**Environmental
Planning
Commission**

**Agenda Number: 01
Project #: 2018-001402
SI-2018-00171
Hearing Date: March 14, 2019**

**Second Supplemental Staff Report
(to be read with the Staff Reports
December 12, 2018 and February 14, 2019 EPC hearing)**

Agent	Consensus Planning
Applicant	Gamma Development LLC
Request	Site Plan-EPC
Legal Description	Lots 1 through 3, Block 1, Plat of West Bank Estates together with Tract A1, Lands of Suzanne H Poole, and Tracts C-1 and Lot 4-A of Plat of Tracts C-1, C-2 and Lot 4-A, Lands of Suzanne H Poole being a Replat of Tract C, Lands of Suzanne H Poole, Tract C, Annexation Plat Land in Section 25 and 36, T11N R2E, Lot 4, Block 1 West
Location	Addressed 5001 Namaste Road NW and between La Bienvenida Place NW and the Oxbow Open Space
Size	23 acres
Existing Zoning	R-A
Proposed Zoning	N/A

SITE PLAN

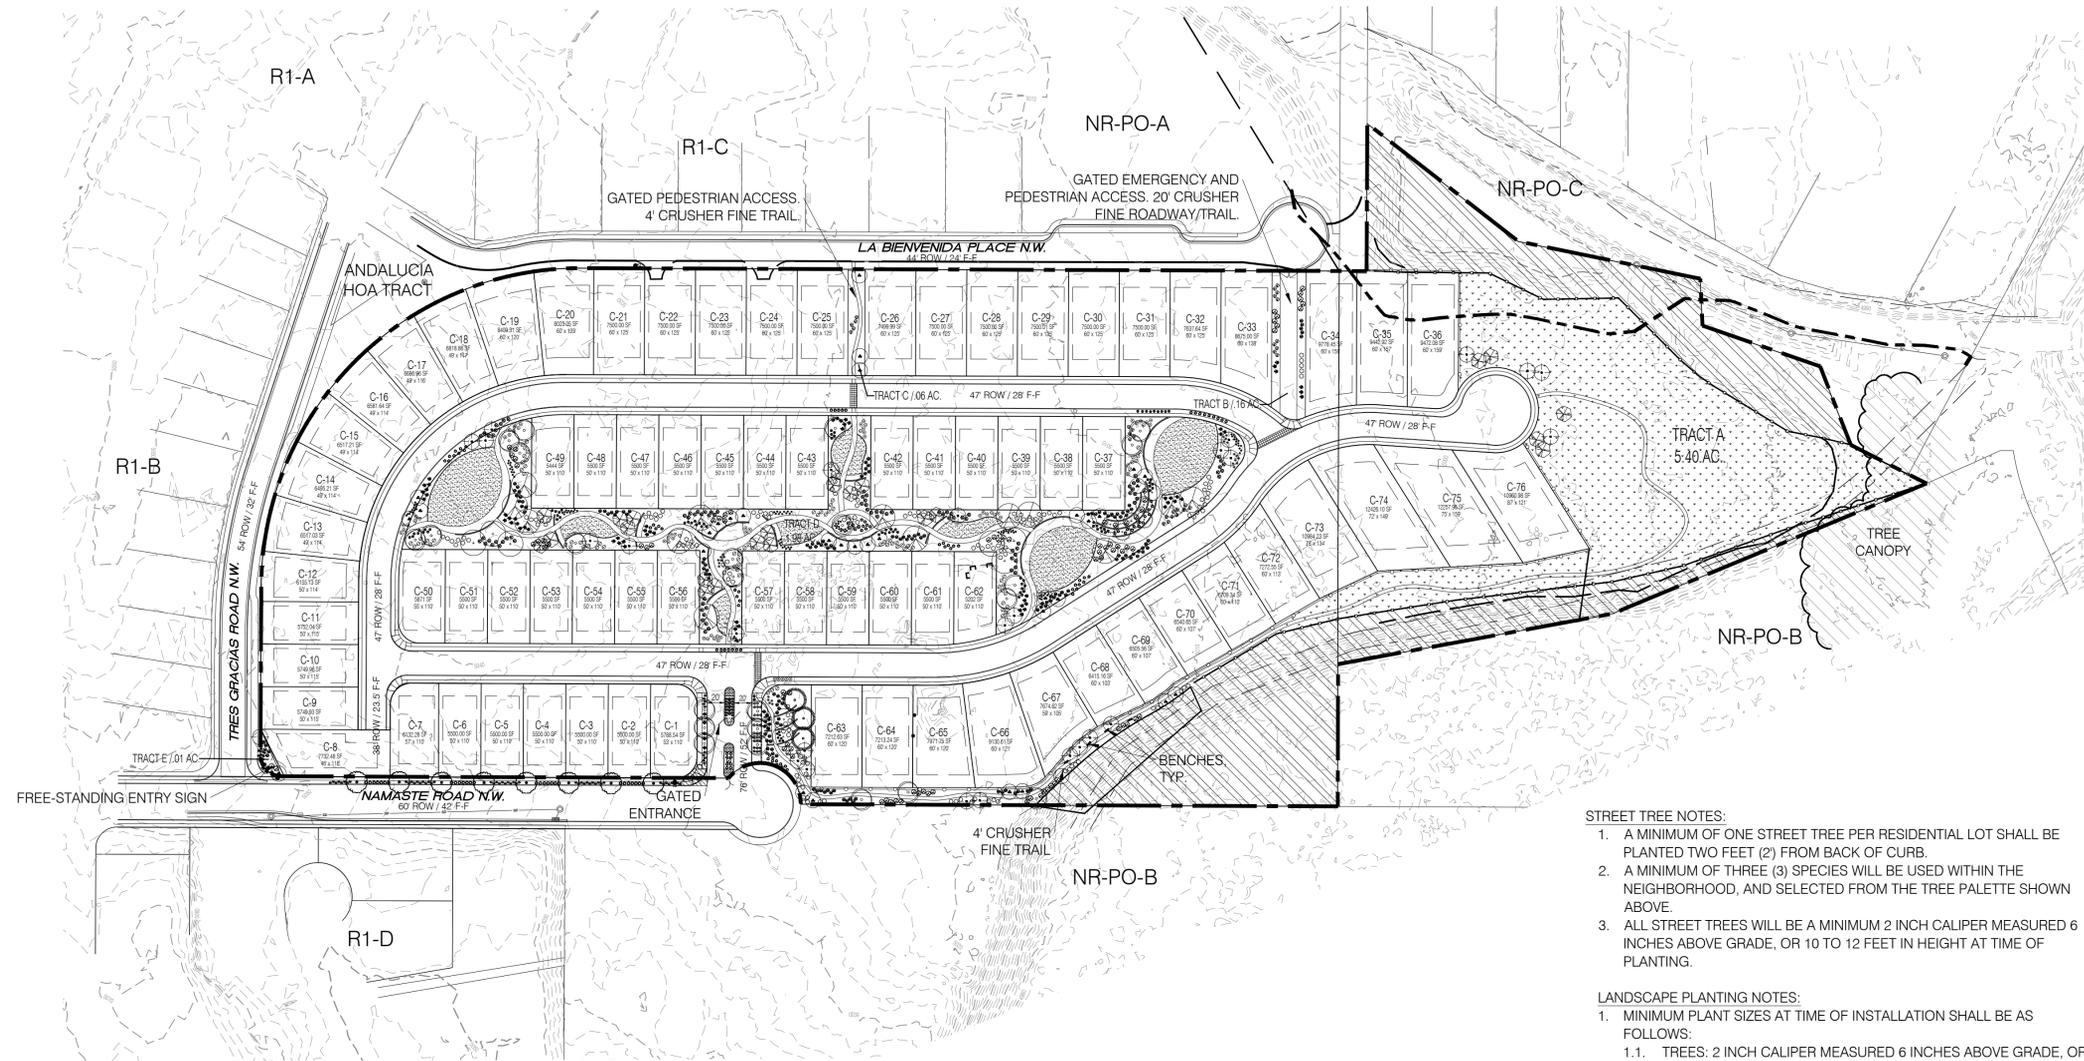
Calling out the appropriate setbacks is a recommended Condition of Approval. The applicant has indicated that they may reduce the common open space in order to meet the setbacks by increasing the size of the lots. If this results in a major change to the Site Plan, it will be required to be reviewed and approved again by the EPC again.

Staff also recommends adjustment of the entrance drive to preserve the stand of trees adjacent to the Namaste cul-de-sac. The applicant cites the Pollen Ordinance as the reason the entrance trees should not be preserved. IDO regulation 5-2(C)(1)(i) is for large stands of mature trees; therefore the intent is to preserve the stand of trees including some existing Desert Willow at the entrance. In addition, the intent of the Pollen Ordinance is to prevent the “growing, sale, importation, or planting” of prohibited trees in the context of newly planted trees by the landscaping industry. The Pollen Ordinance does not state that existing trees should be removed.

The applicant’s updated Site Plan minimizes street crossings by eliminating another internal north-south street, and instead uses this area as a pedestrian trail and common open space. The cul de sac extends farther to the east than seems necessary.

Staff recommends that a note be added to the Site Plan that all provisions of 5-2(H) Major Public Open Space Edges will be applied to new construction.

The Landscape Plan shows primarily naturalized vegetation for landscaping materials. Staff recommends that a note be added to the Site Plan that states Buildings and Landscapes will comply with 5-2(H)(1).

CONCEPTUAL GRADING AND DRAINAGE PLAN

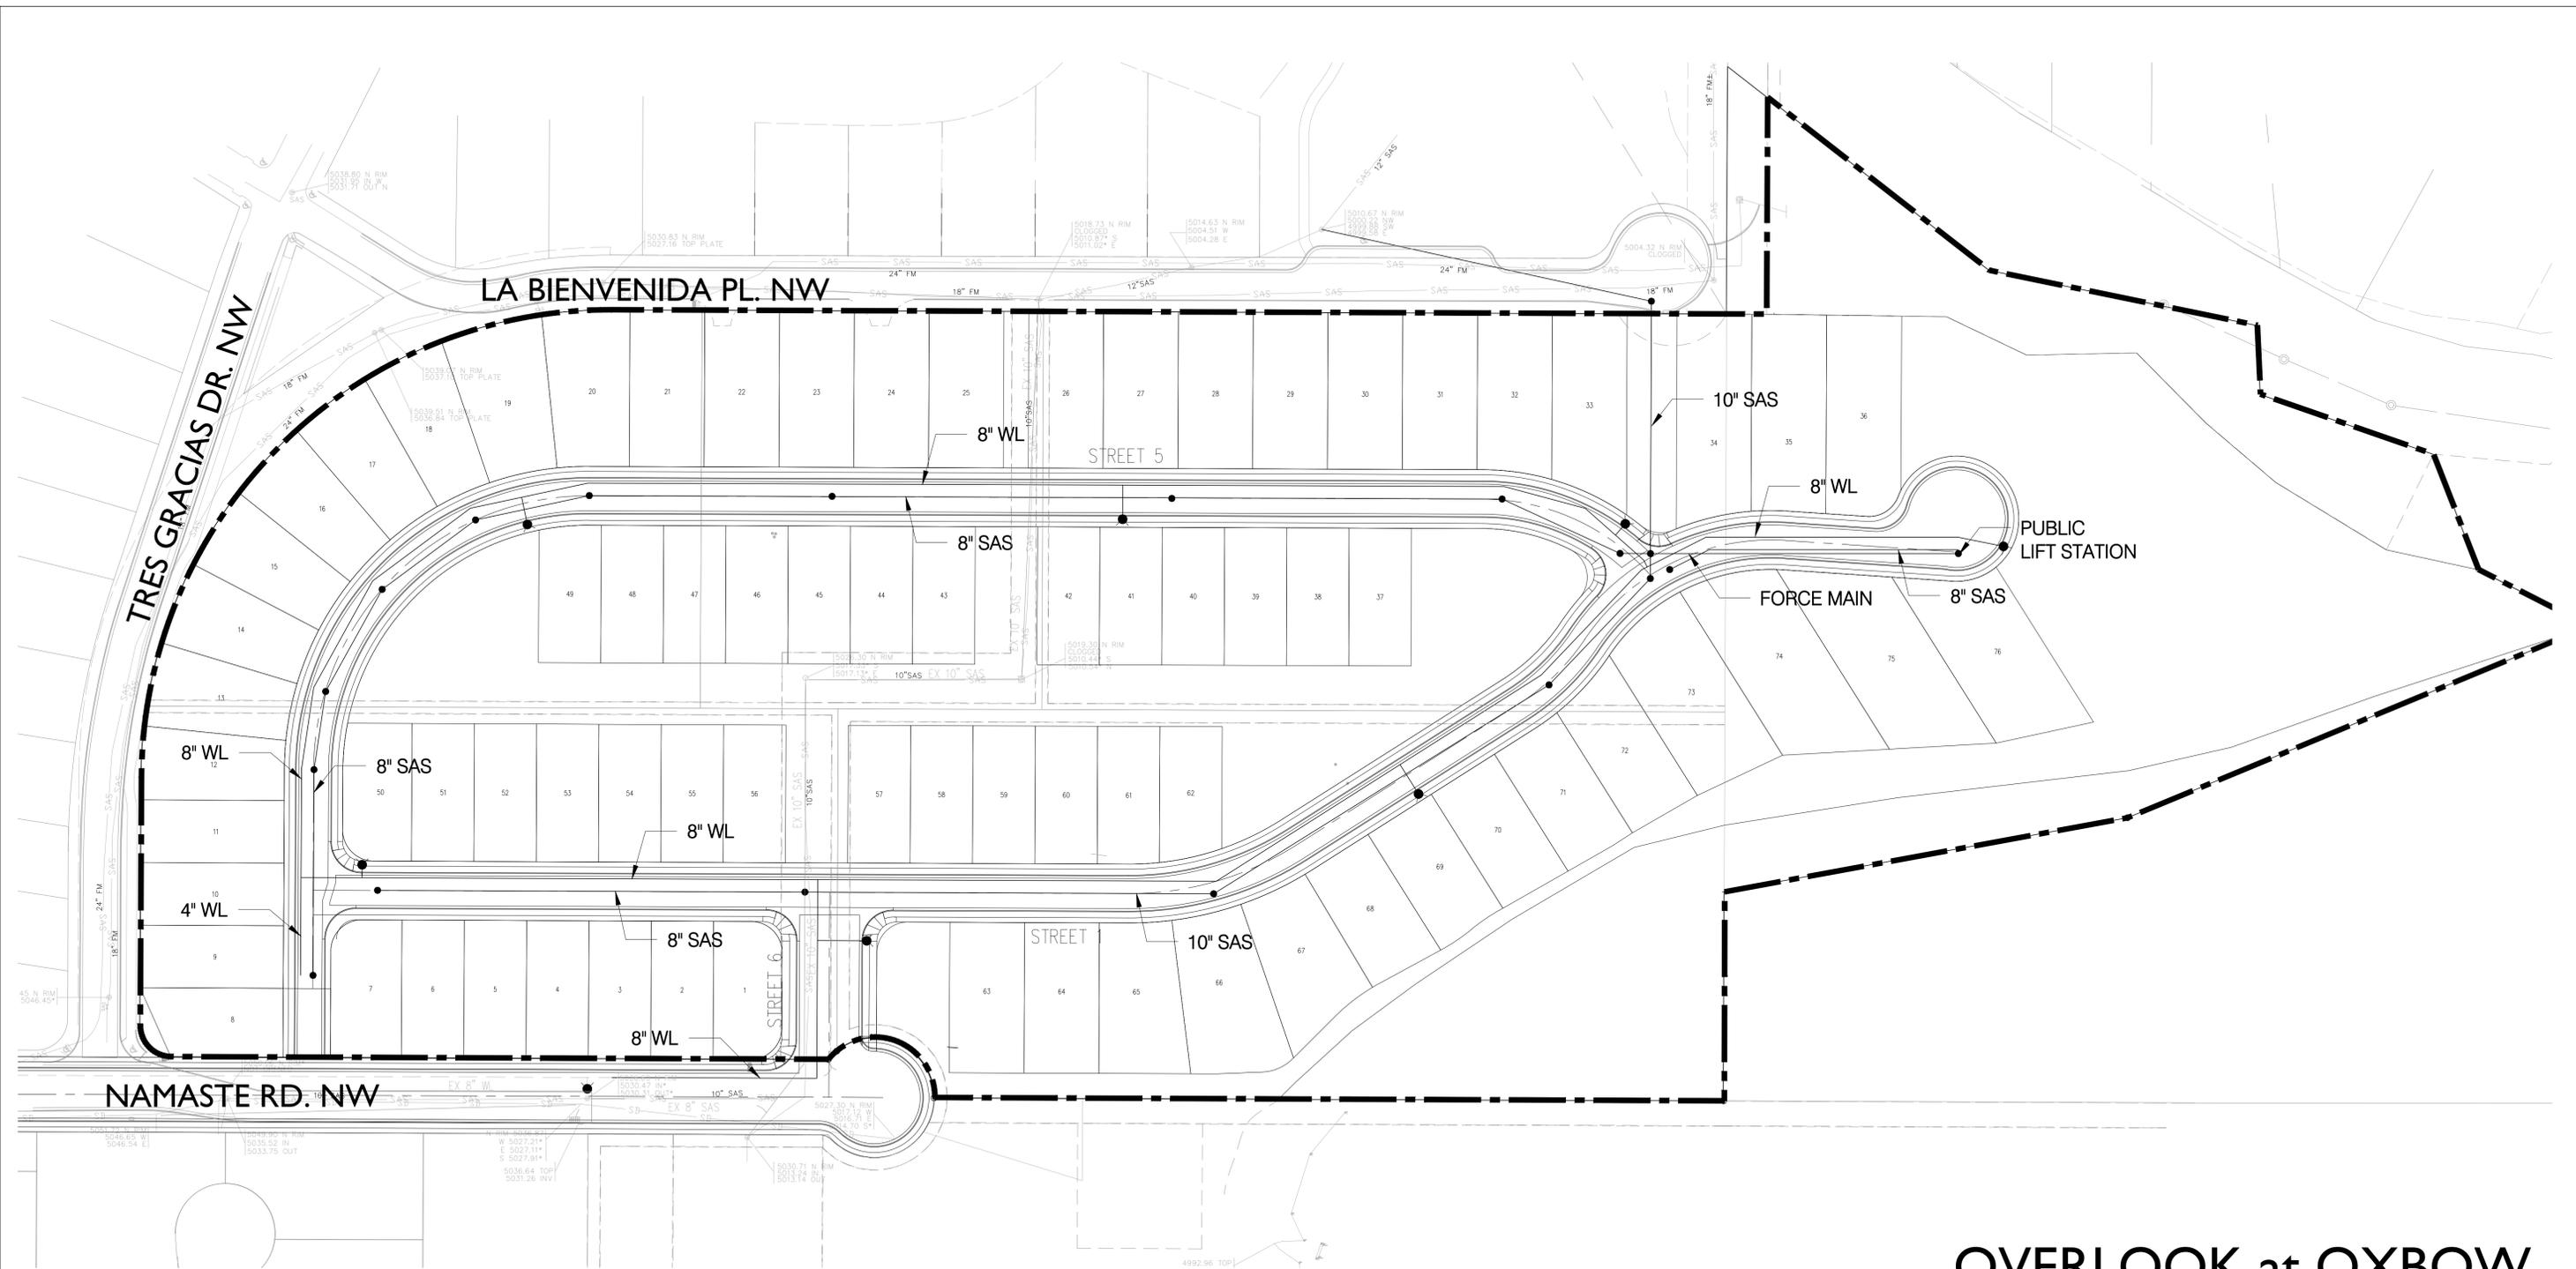
The applicant indicates a Flood Zone area on the Sensitive Areas exhibit and the Grading and Drainage Plan shows an “Approximate Location of Existing FEMA Flood Zone”; however, the applicant has indicated that the flood zone line should have been adjusted due to work on the adjacent detention pond to the north. The City Hydrologist states that a Letter of Map Revision (LOMR) will be required to remove the floodplain from the lots that have the floodplain, and this is Note 1 on the applicant’s Conceptual Grading and Drainage Plan.

Staff recommends this project proceed to DRB review and approval for technical issues such as this, and if Lots C-34-C-36 remain in the flood zone that they be relocated on the Site Plan.

- Management onsite will be required for the SWQV unless a waiver is demonstrated on the G&D Plan and accepted by Hydrology.
 - Note 4 on sheet 3 is incorrect and should be removed. Replace with a note that says “A prudent setback will be established to allow for the future construction of bank protection by the HOA on the HOA’s property without any encroachment into the Open Space property or on any of the lots.”

Appendix 3: Developer's Conceptual Site Plans

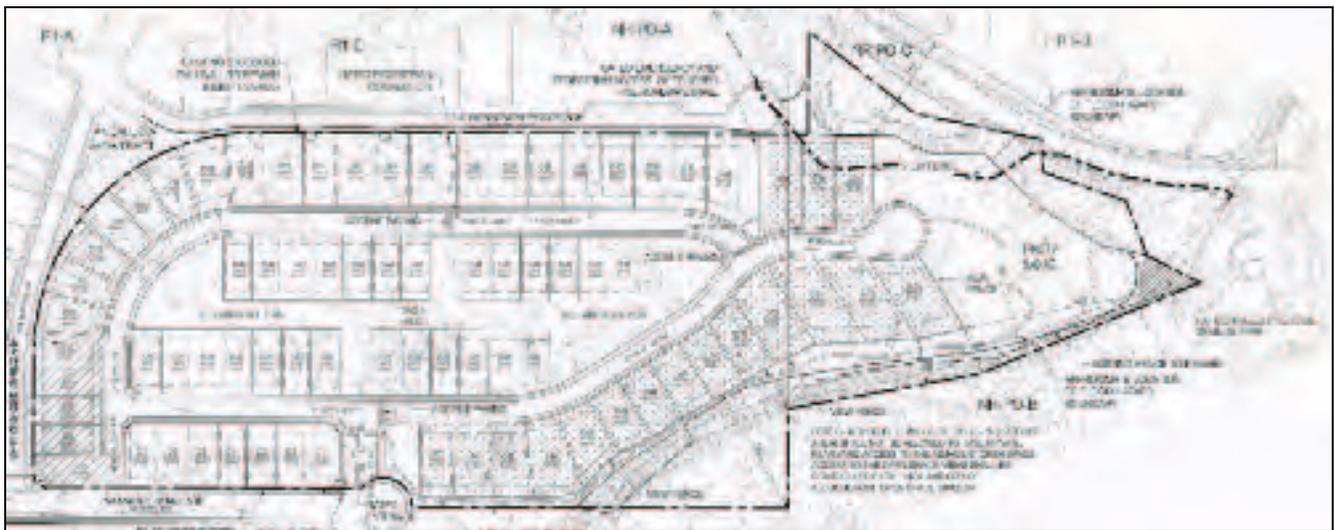
Site proposes 76 single-family conventional homes on 23.75 acres without proper buffers to sensitive lands, wetland, bosque, river, and major public open space.

Site plan does not show that property abuts and is adjacent to:

- Rio Grande River
- Rio Grande Valley State Park
- Bosque
- Oxbow Wetland
- Major Public Open Space & Trails
- Public Arroyo
